ARKANSAS NUCLEAR ONE, UNIT NO. 1

AMENDMENT TO FACILITY OPERATING LICENSE

Amendment No. 37
License No. DPR-51

ATTACHMENT TO LICENSE AMENDMENT NO. 37

FIGURE 6.2-1

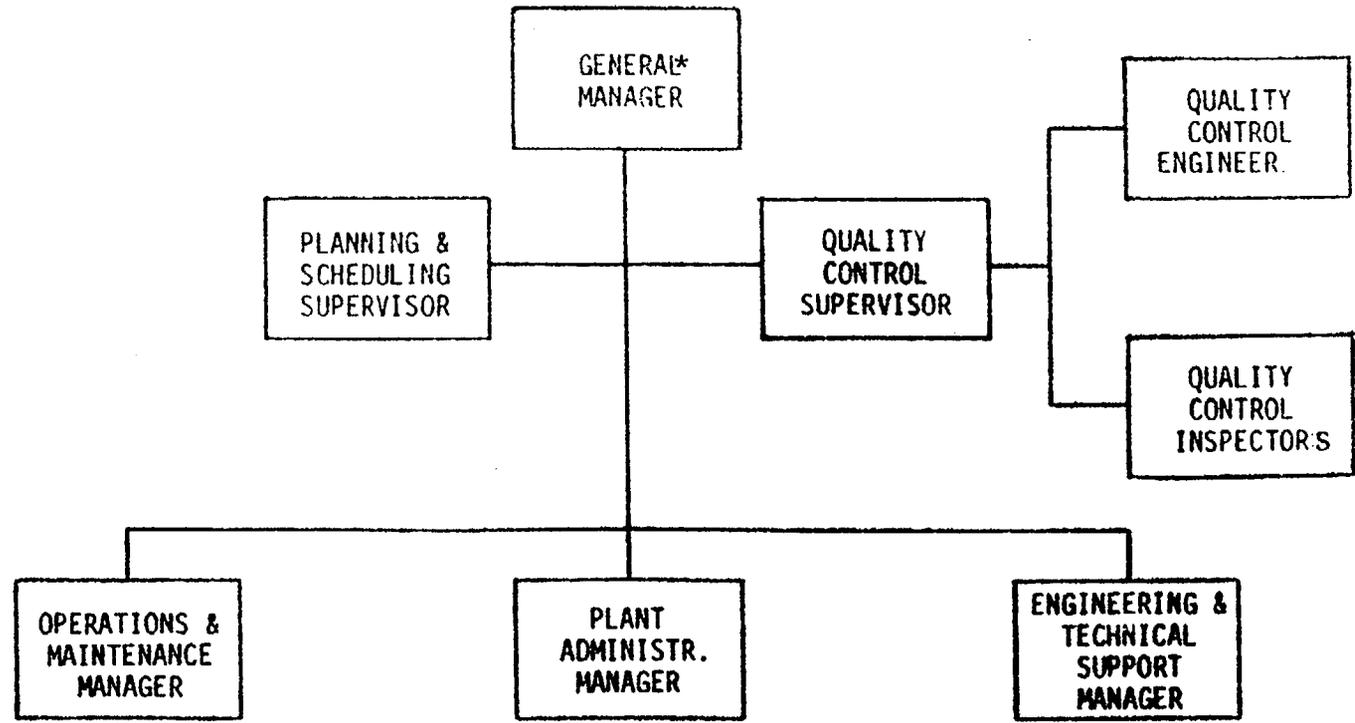
- 6.2.1. The offsite organization for facility management and technical support shall be as shown on Figure 6.2-1.

Figure 6.2-2A

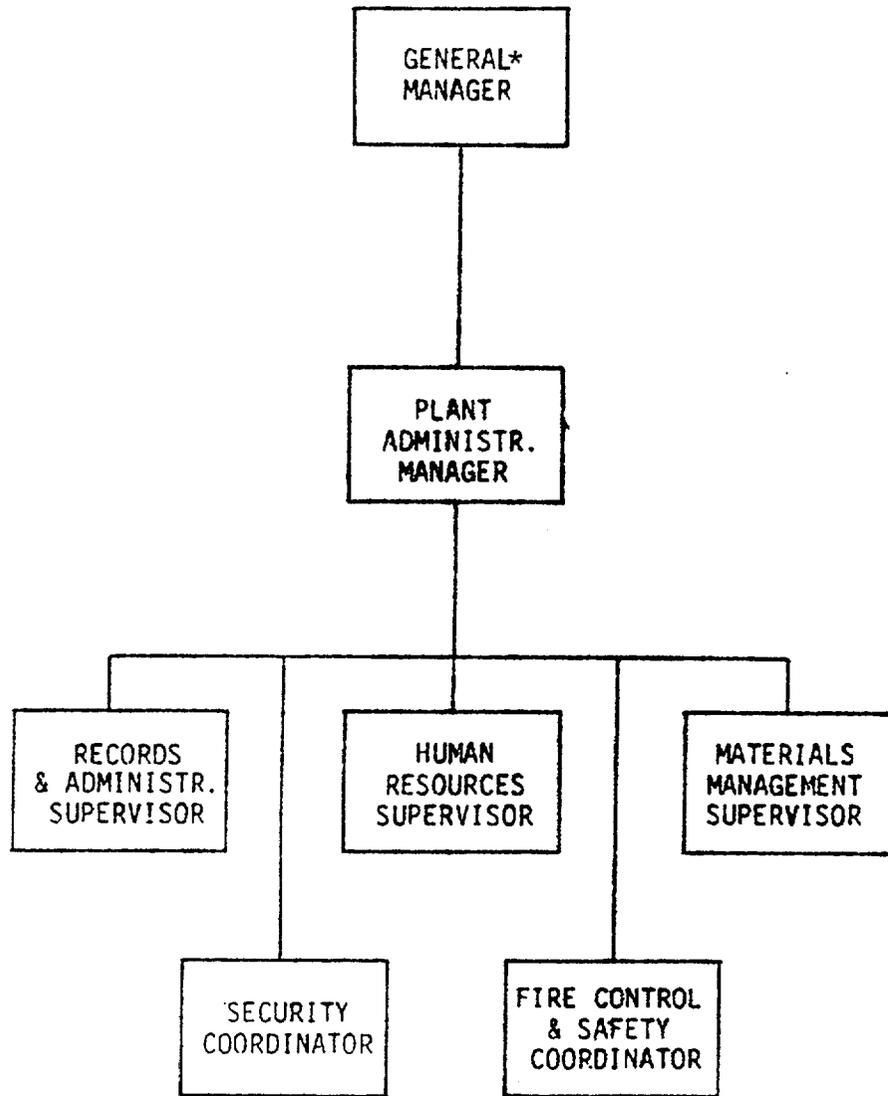
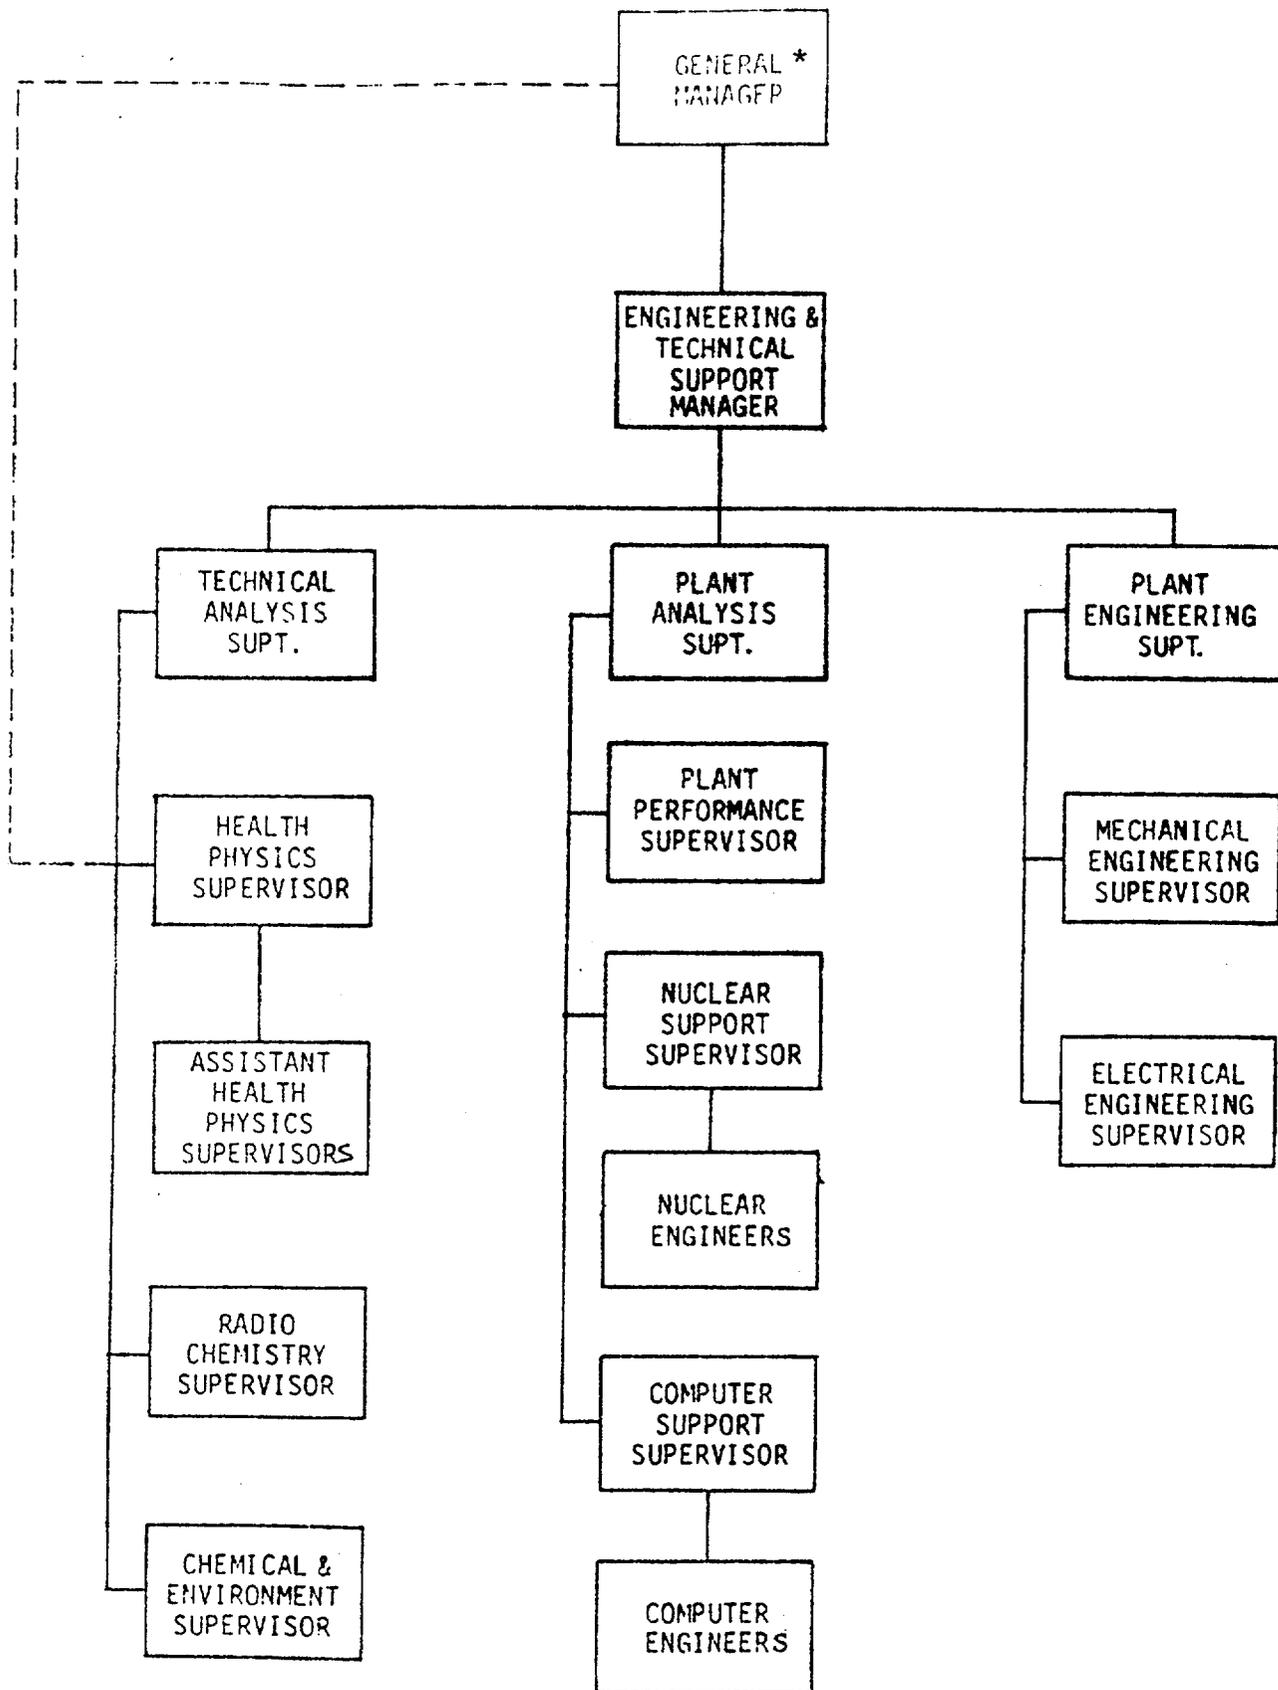
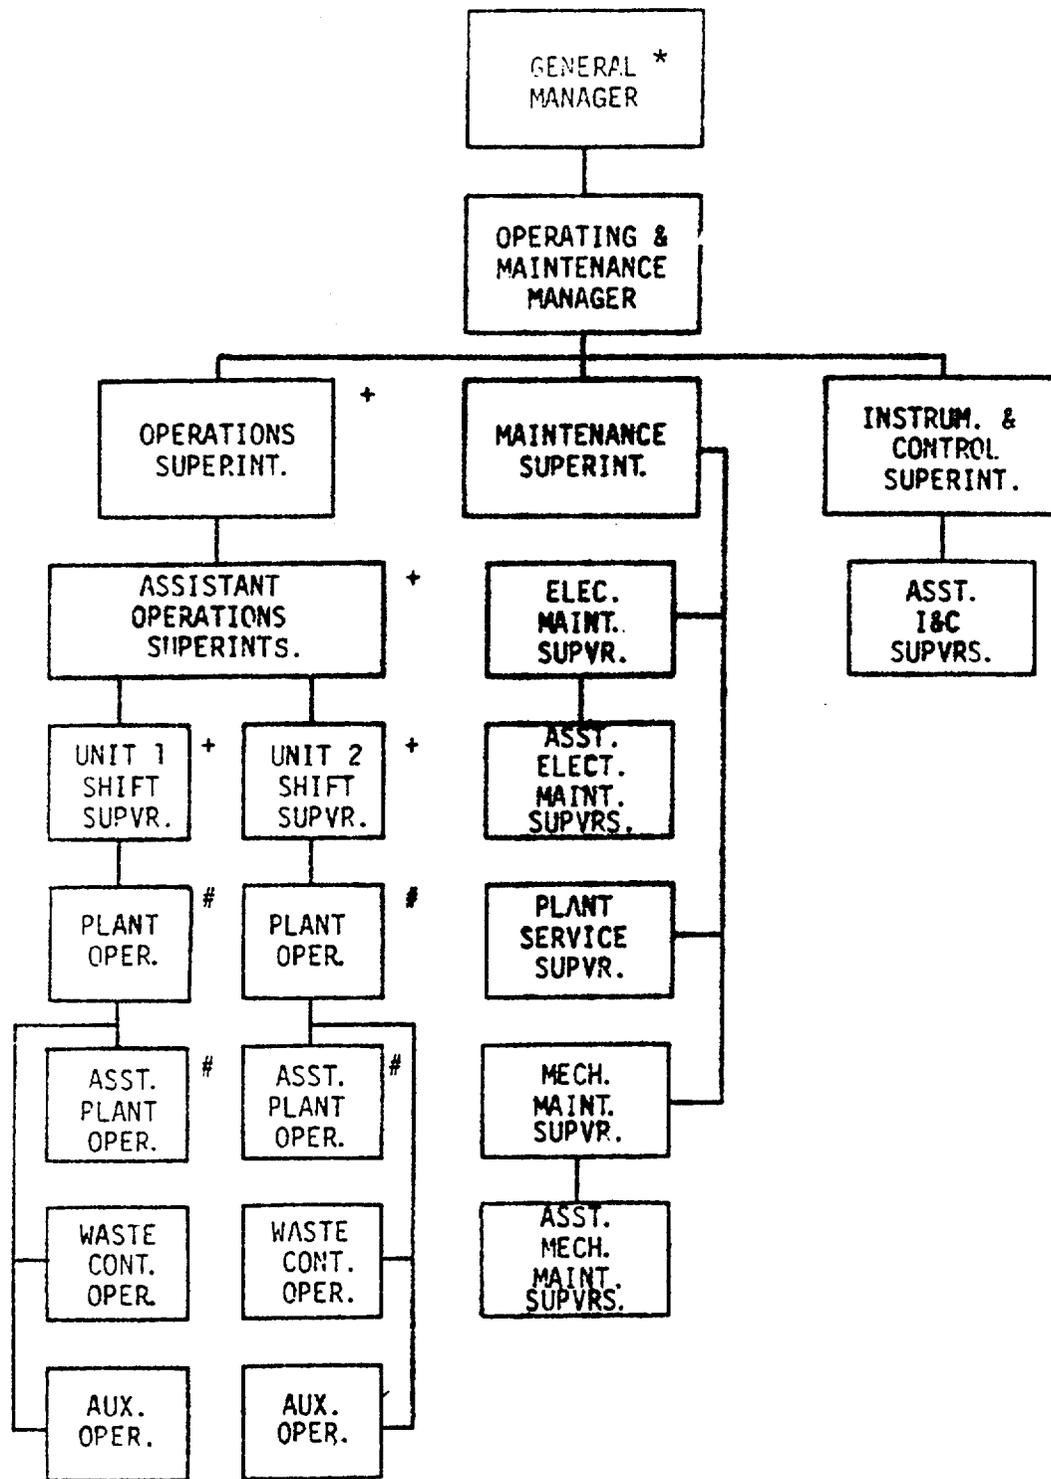
- 6.2.2 The Facility organization shall be as shown on Figures 6.2-2A, B, C, and D. Each on duty shift shall be composed of at least the minimum shift crew composition shown in Table 6.2-1.

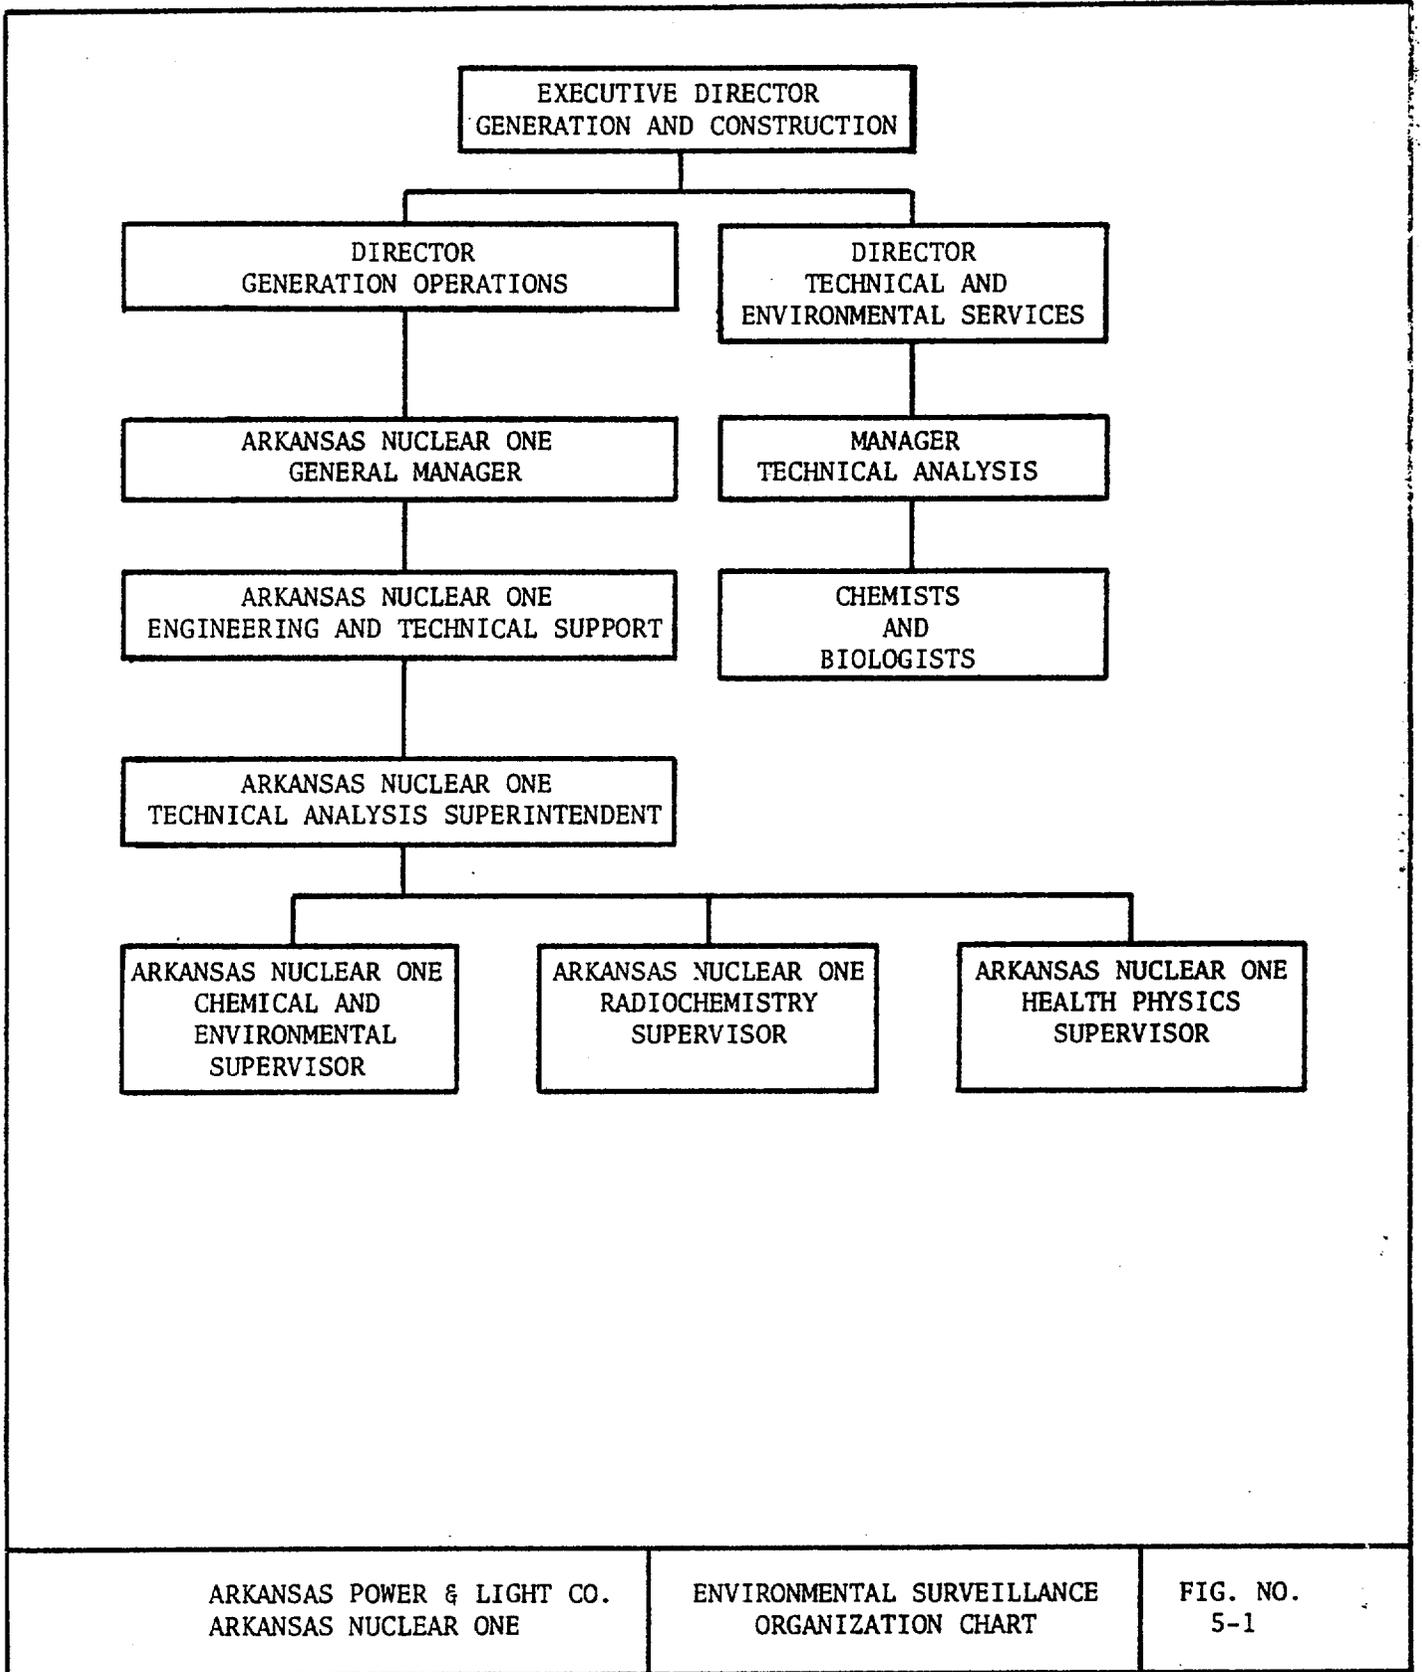
Figure 5-1 shows the organization chart at both plant and corporate levels relative to environmental matters.

Figure 6.2-1 Management Organization Chart

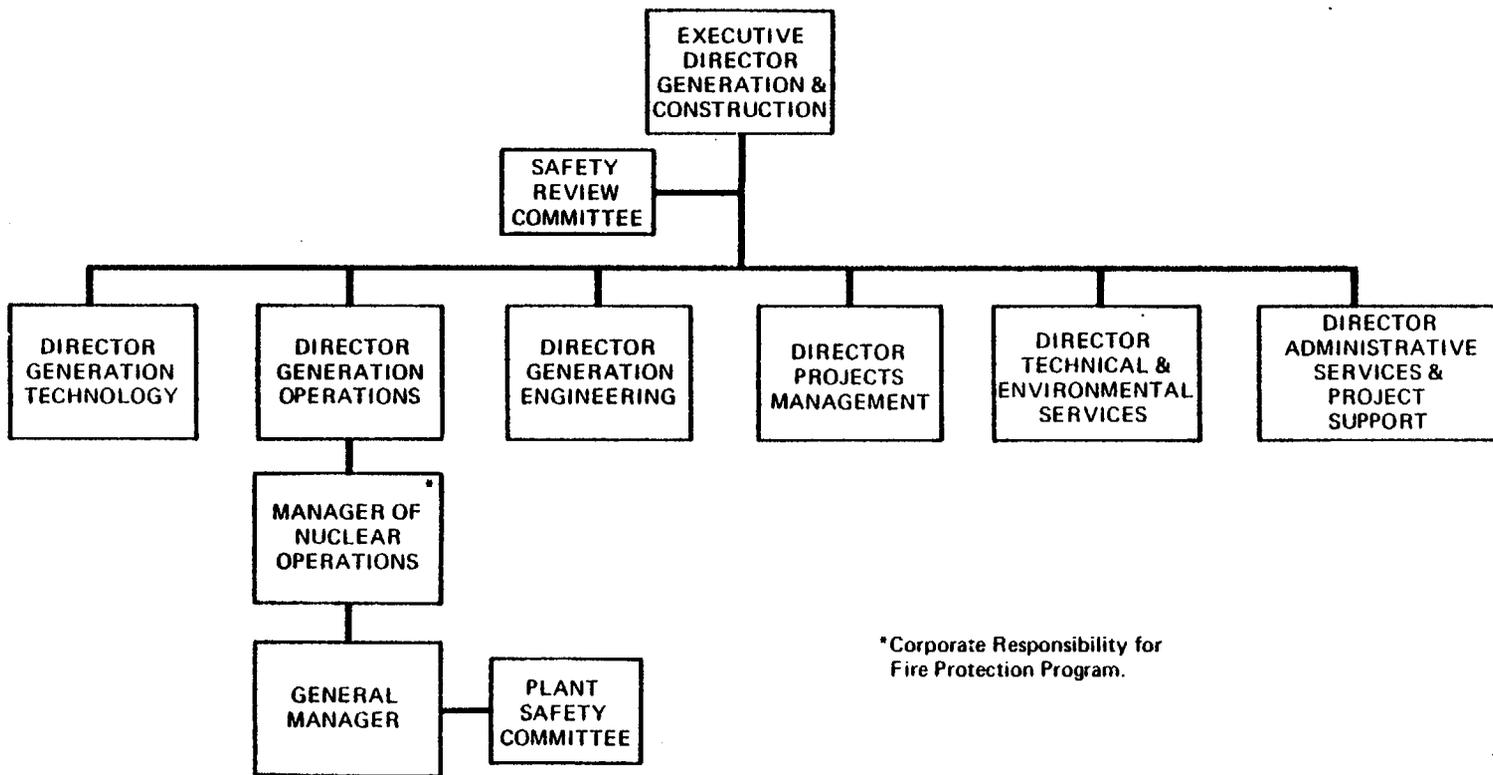
6.2.1 The offsite organization for facility management and technical support shall be as shown on Figure 6.2-1.

Figure 6.2-2 Functional Organization for Plant Operation

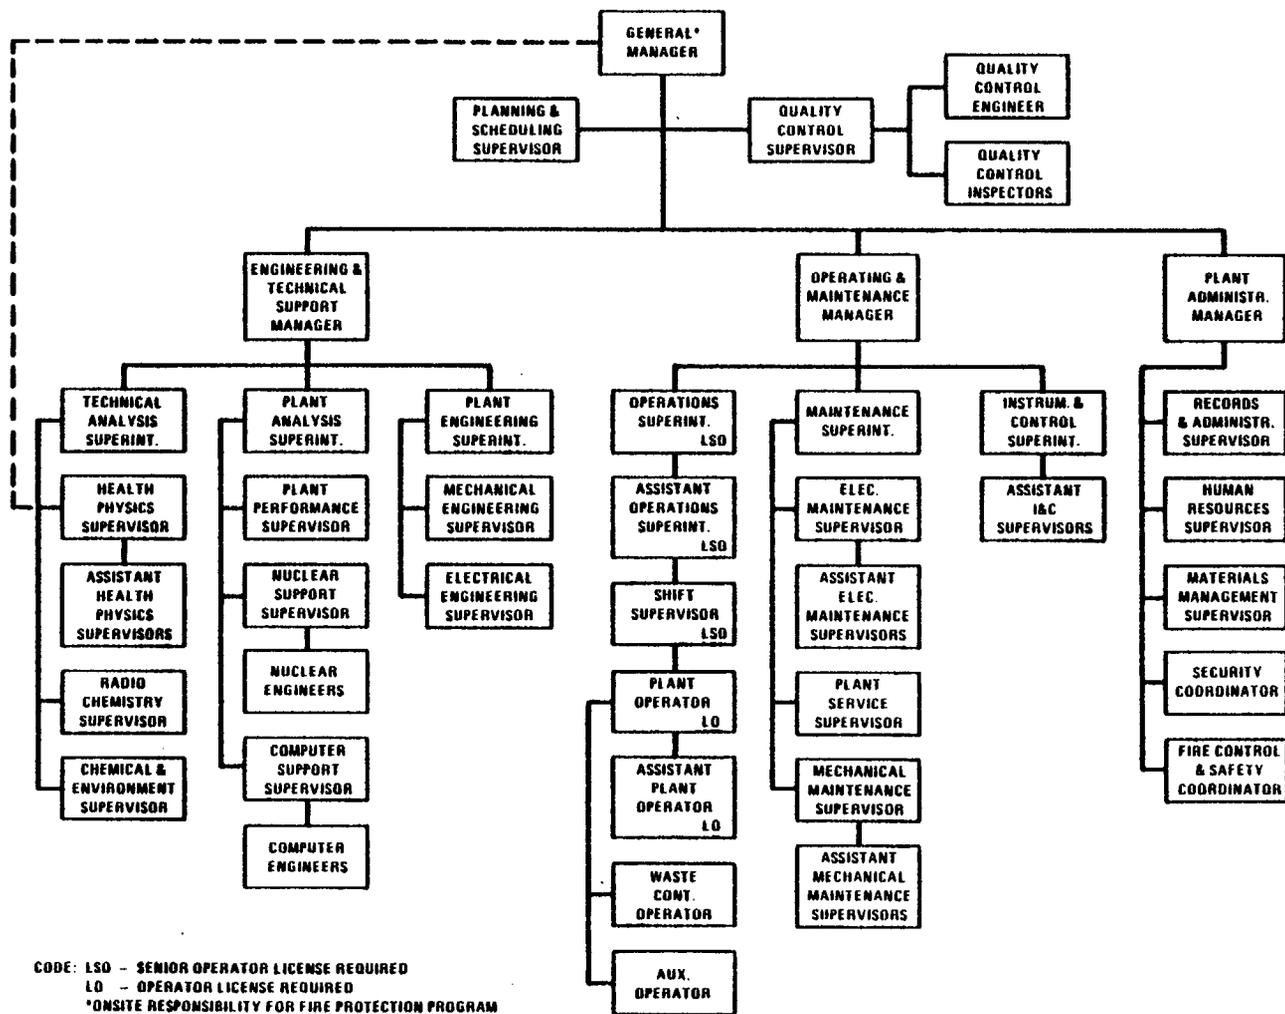
6.2.2 The Facility organization shall be as shown on Figure 6.2-2 and:
